TECH-HINT

Helical fixed folders

MACHINE TYPE: X2 REFERENCE CODE: X2.79

Helical fixed folders

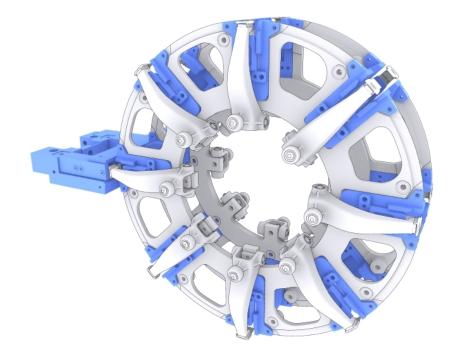
The helical fix folder simplifies the execution of innerliner folding.

The kit features new second wheel pockets with fitted folders and upgraded mouthpiece with fixed helical folding features. The new group removes all moving folders on the 2nd wheel which reduces the need for several spare parts, improves the quality of folds and simplifies the setup. As the bundle transfers from the 1st wheel into the 2nd wheel, the innerliner begins to fold around it. The bundle then transfers to the 3rd wheel through the newly designed helical folder mouthpiece completing the remaining folds.
